Middlesex Avenue over Lubbers Brook Culvert  
Addendum No. 2

**Town of Wilmington, MA  
Department of Public Works**

**Addendum No. 2**

**Middlesex Avenue over Lubbers Brook Culvert  
Bid Opening on February 2, 2022 at 1:00 PM**

**SOUTH WEST WALL ELEVATION VIEW (STEPPED FOOTING DETAIL)**  
SCALE: 1/2" = 1'-0"

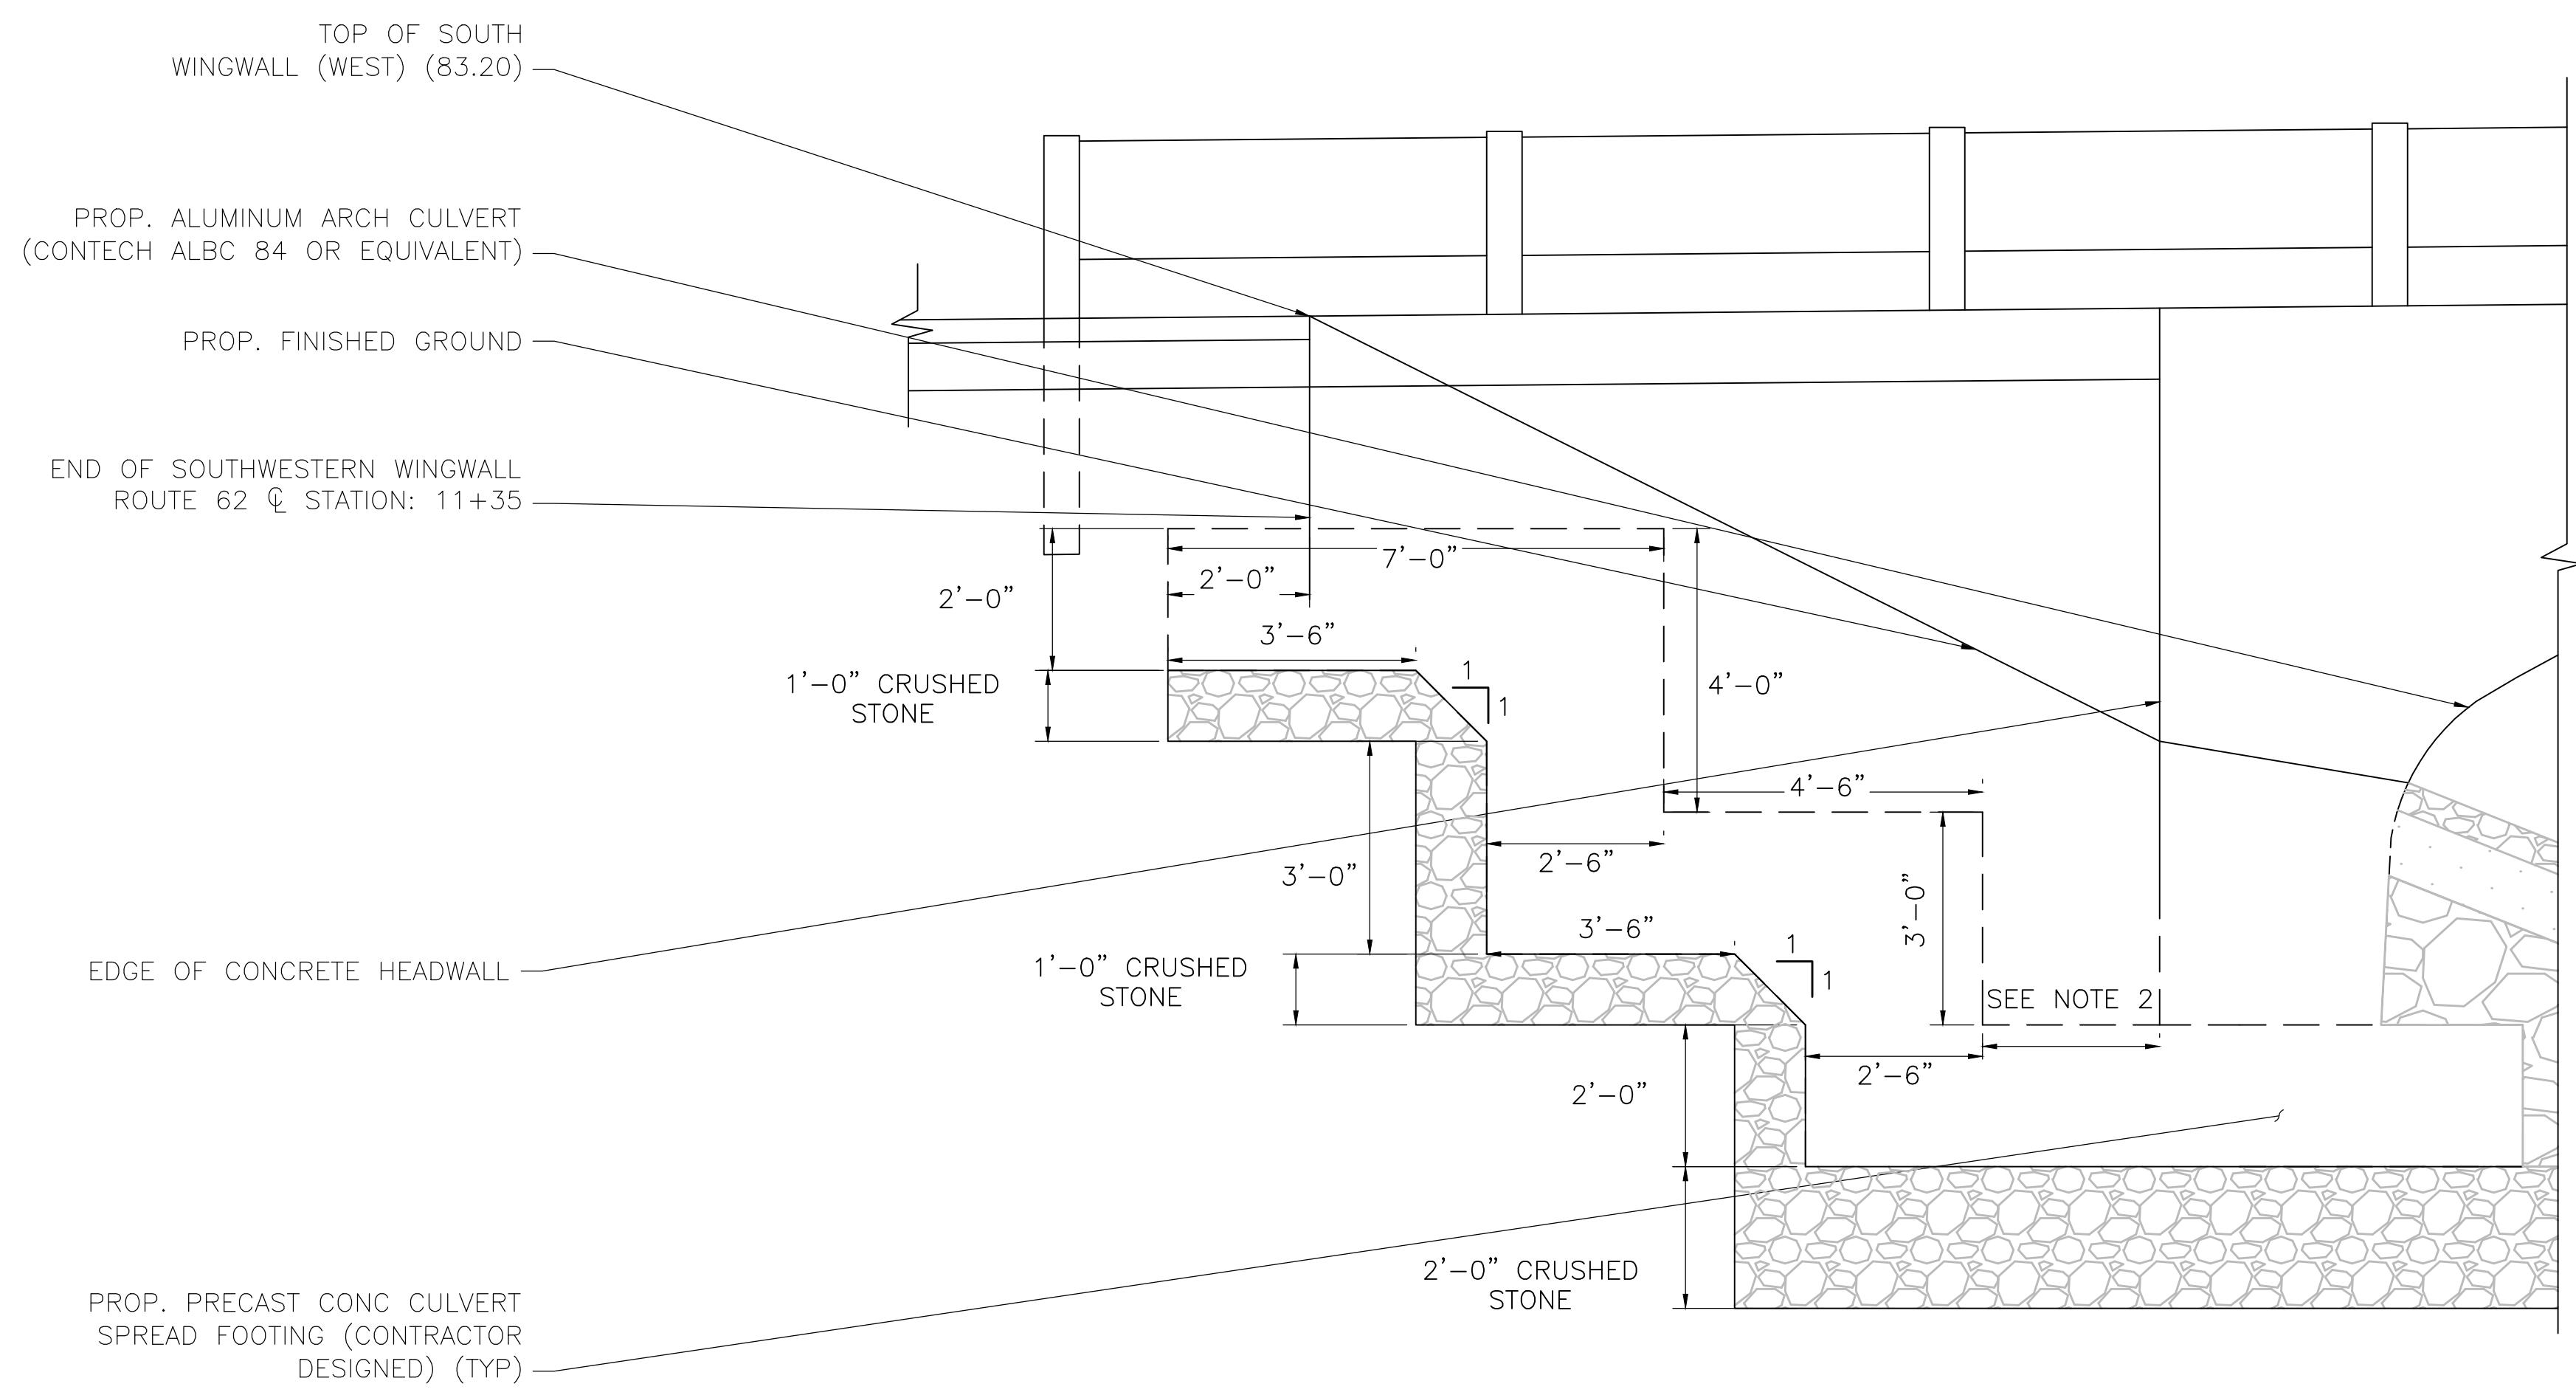
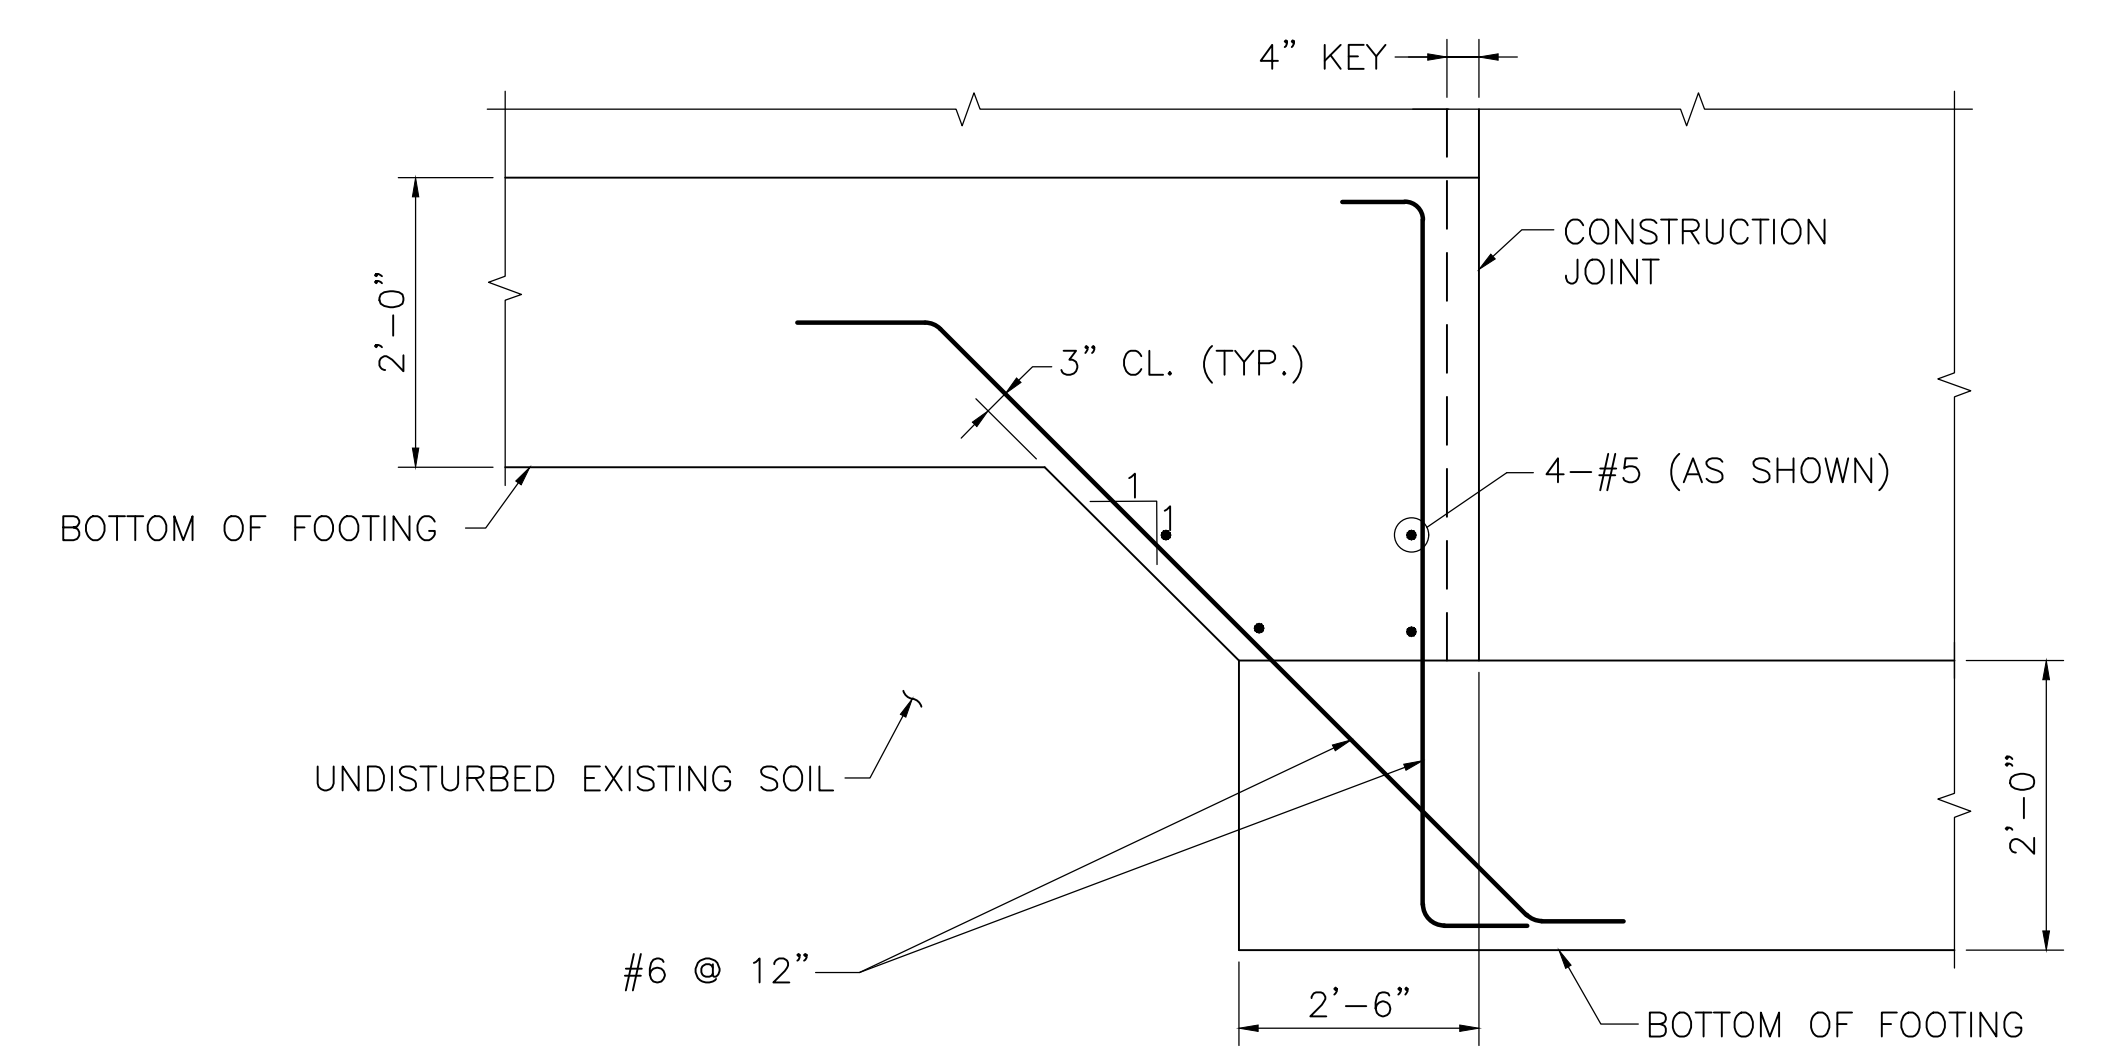
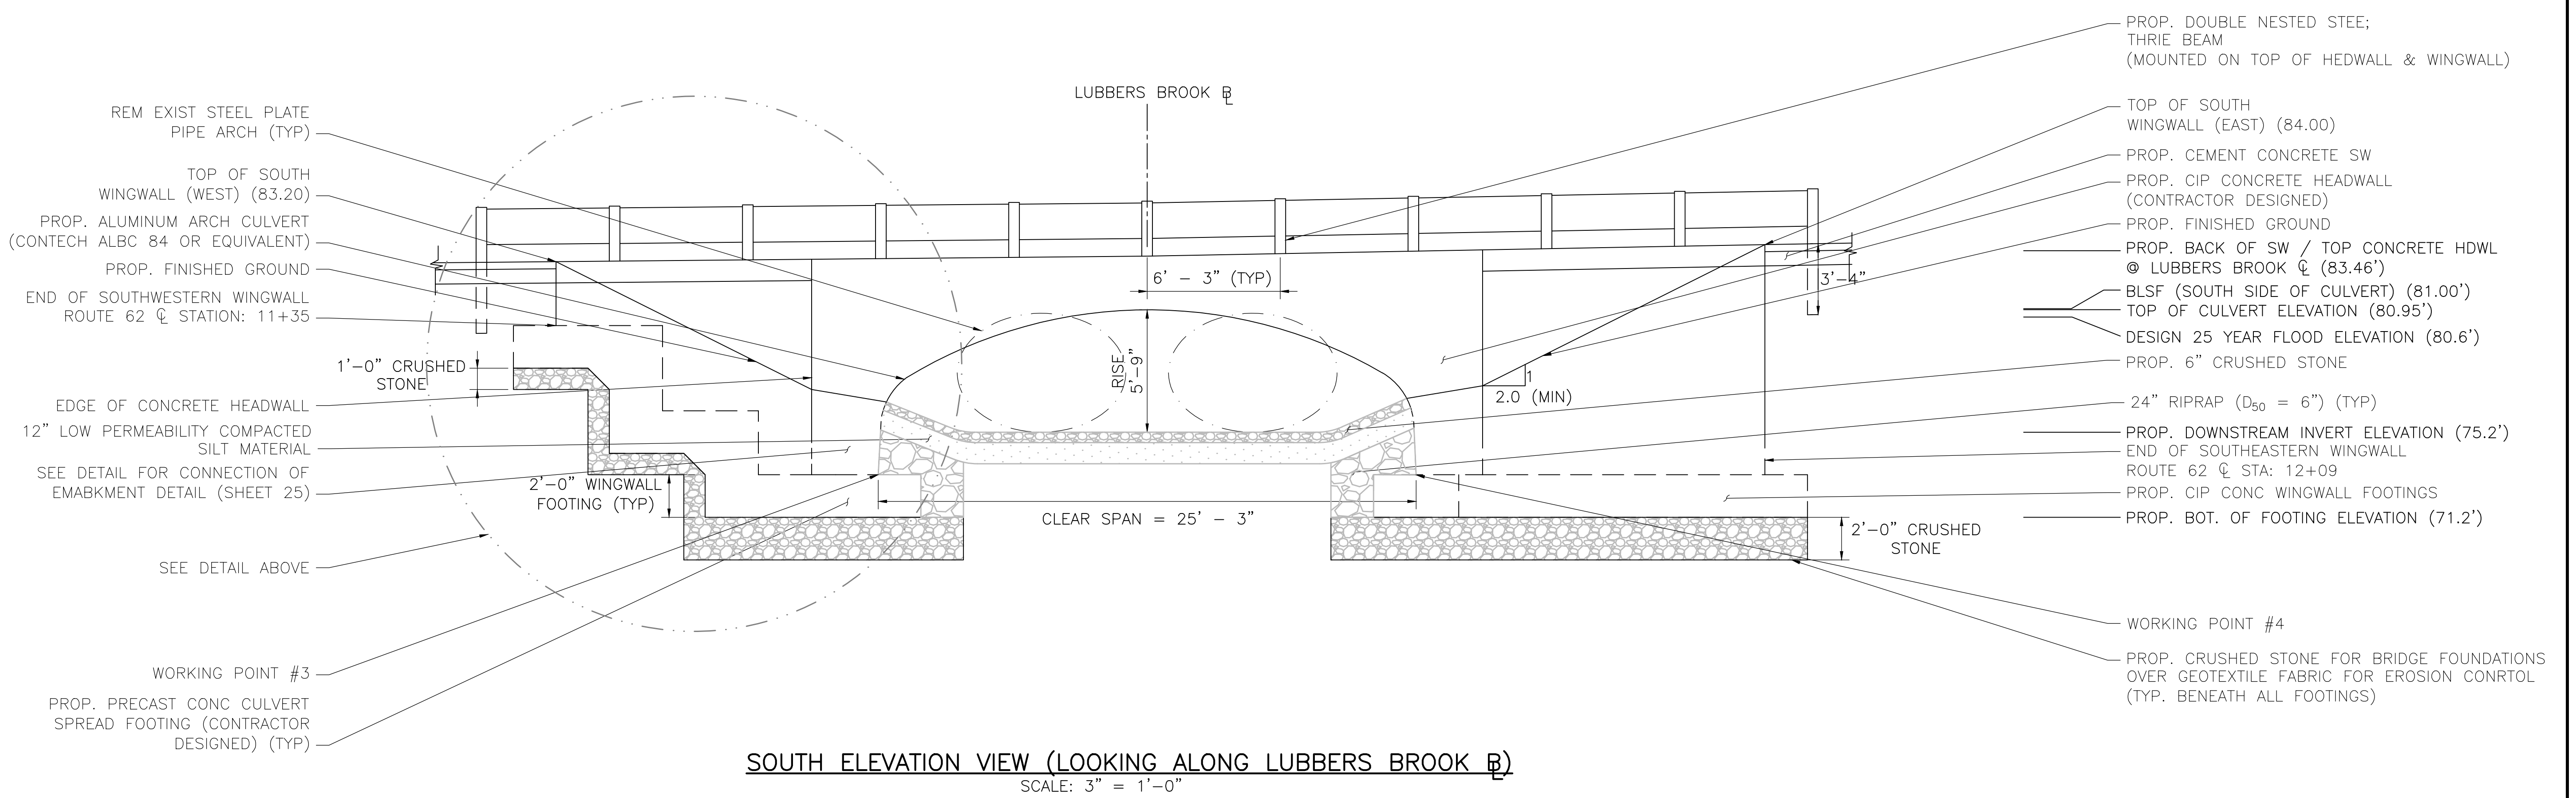
The enclosed drawings include a revision to the downstream headwall. See the attached sheets. The existing Sheet 24 shall be removed and replaced with the attached Sheet 24. And Sheet 24A shall be added to the plan set (also attached).

Regarding the utility pole at Sta 11+25, 25' RT. The pole is approximately 10' from the end of proposed wingwall that requires a 16' cut to install. Please provide a complete disposition of this pole relative to who bares the expense of moving or holding, timing of such, if holding in place, what will contractor encounter that may impede his work.

The footing at this location is now being stepped (see attached drawings). The excavation depth will shrink from 16' to 6' at this location. Given that the end of the proposed wingwall is 10' from the pole, it is not envisioned that excavation will be necessary near the pole other than installation of the sidewalk.

2 ADDENDUM SEE SHEET 24A
